UNITED STATES  
DEPARTMENT OF THE INTERIOR  
BUREAU OF LAND MANAGEMENTFORM APPROVED  
OMB NO. 1004-0137  
Expires: January 31, 2018**SUNDRY NOTICES AND REPORTS ON WELLS**  
*Do not use this form for proposals to drill or to re-enter an abandoned well. Use form 3160-3 (APD) for such proposals.*5. Lease Serial No.  
NMNM118108

1. Type of Well <input type="checkbox"/> Oil Well <input checked="" type="checkbox"/> Gas Well <input type="checkbox"/> Other		8. Well Name and No. HH SO 8 P2 22H
2. Name of Operator CHEVRON U.S.A. INC. <4323> Contact: DORIAN K FUENTES E-Mail: DJVO@CHEVRON.COM		9. API Well No. 30-015-43928
3a. Address ATTN: DORIAN K. FUENTES 6301 DEAUVILLE BLVD MIDLAND, TX 79706	3b. Phone No. (include area code) Ph: 432-687-7631	10. Field and Pool or Exploratory Area PURPLE SAGE; WOLFCAMP (GAS)
4. Location of Well (Footage, Sec., T., R., M., or Survey Description)  Sec 17 T26S R27E Mer NMP NWNW 230FNL 960FWL 32.049144 N Lat, 104.217790 W Lon		11. County or Parish, State  EDDY COUNTY, NM

Chevron respectfully requests the ability to change the BOPE rating for the selected well from a 10M system to a 5M system. The max mud weight at 10500' for the pore pressure is a 13.0 ppg. Th

# FMC Technologies

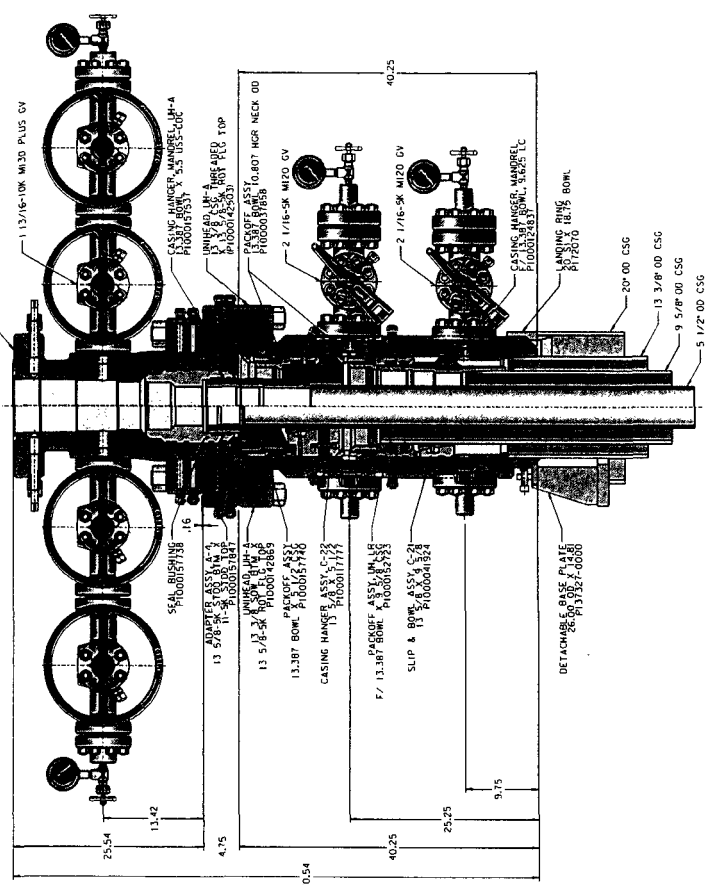
Chevron requests a variance to use a FMC Technologies UH-2 multibowl wellhead, which will be run through the rig floor on surface casing. BOPE will be nipped up and tested after cementing surface casing. Subsequent tests will be performed as needed, not to exceed 30 days. The field report from FMC Technologies and BOP test information will be provided in a subsequent report at the end of the well. Please refer to the attached wellhead schematic.

**Operator has proposed a multi-bowl wellhead assembly. This assembly will only be tested when installed on the surface casing. Minimum working pressure of the blowout preventer (BOP) and related equipment (BOPE) required for drilling below the surface casing shoe shall be 5000 (5M) psi.**

- a. Wellhead shall be installed by manufacturer's representatives, submit documentation with subsequent sundry.**
- b. If the welding is performed by a third party, the manufacturer's representative shall monitor the temperature to verify that it does not exceed the maximum temperature of the seal.**
- c. Manufacturer representative shall install the test plug for the initial BOP test.**
- d. Operator shall perform the intermediate casing integrity test to 70% of the casing burst. This will test the multi-bowl seals.**
- e. If the cement does not circulate and one inch operations would have been possible with a standard wellhead, the well head shall be cut off, cementing operations performed and another wellhead installed.**
